M224,
M224A1
Mortar...

GET THE TORQUE RIGHT

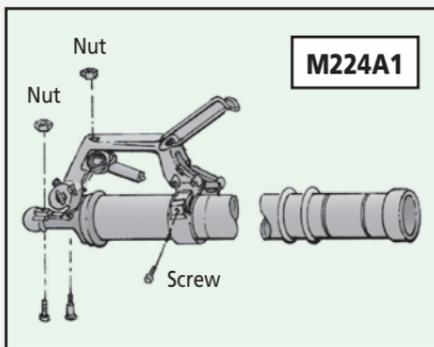
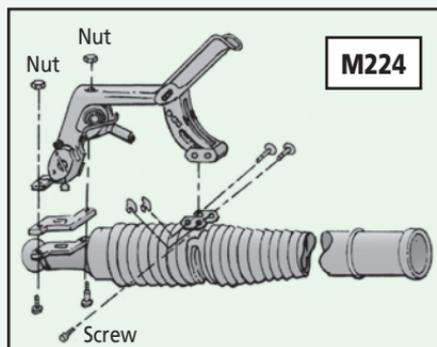
If the hardware for the handle and firing mechanism on the M224 and M224A1 mortars isn't torqued correctly, the mortars may not fire.

*M224: Tighten the self-locking screw and nuts to 10 + 2 lb-ft (13.6 + 2.7 N·m).

*M224A1: Torque the two new self-locking nuts to 10 + 2 lb-ft (13.6 + 2.7 N·m). Torque the shoulder screw into the loop clamp to 12.5 + 2 lb-ft (17.0 + 2.7 N·m).
